**Submittal No: 05500-015**

PROJECT: **Harold Thompson Regional WRF**  
Birdsall Rd.  
Fountain, CO 80817  
Job No. 2908

SUBJECT: Tread Plates for UV Utility Chase (SD-09)

**Submittal for: 05500-015 – Tread plates for UV utility chase**

DWG BY: **TPP** CHK BY: **REQ**  
 DATE: **APR 06 2012**  
 SHEET NUMBER: **SD - 09**

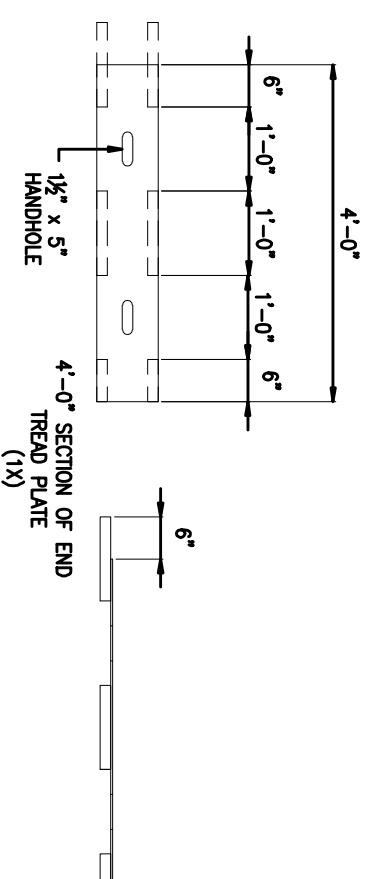
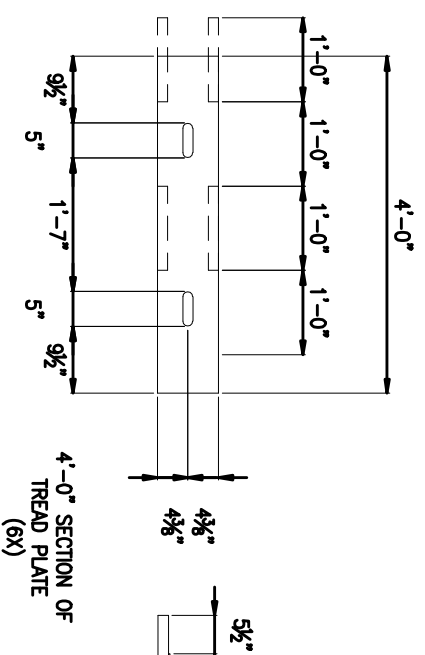
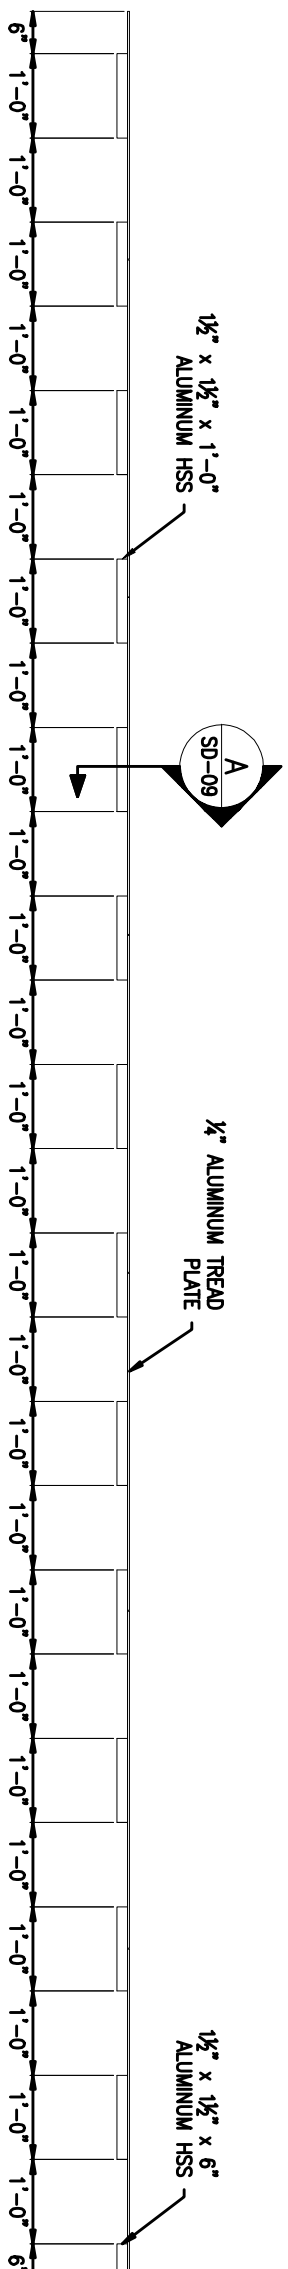
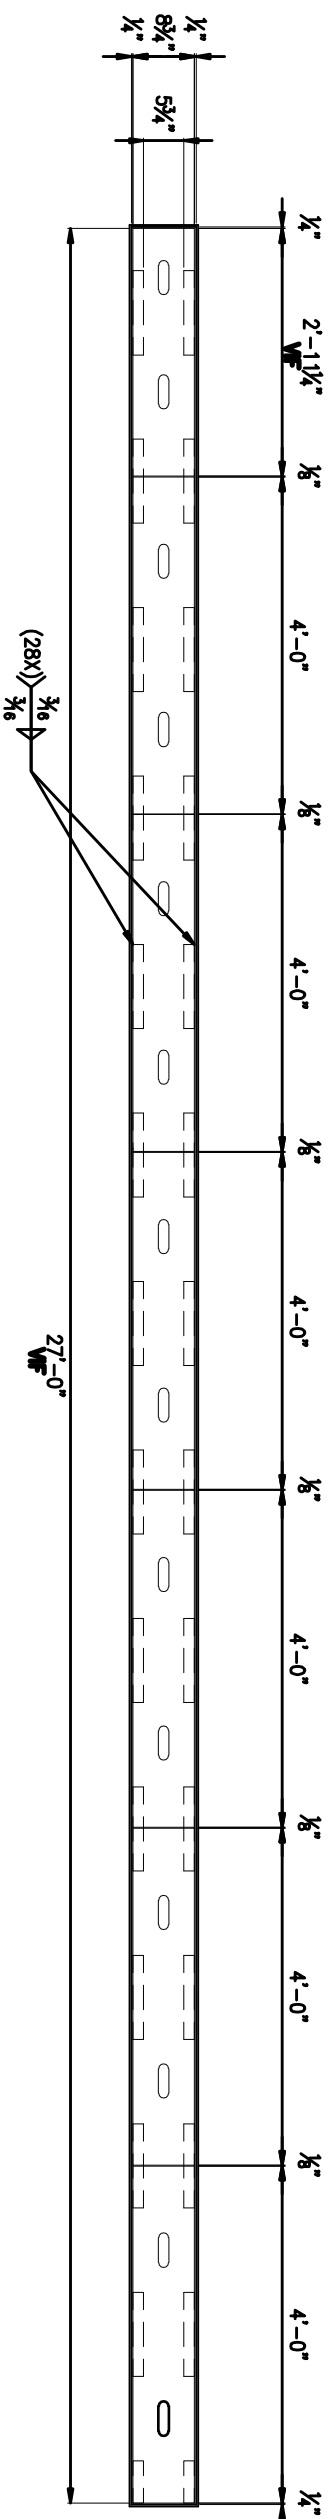
- 1) Chase will be field measured for accurate fitment prior to fabrication.**
- 2) Hand holes will be smooth enough so as not to injure operators when removal is necessary.**
- 3) Sections at either end will have HSS at very end to ensure they are supported.**
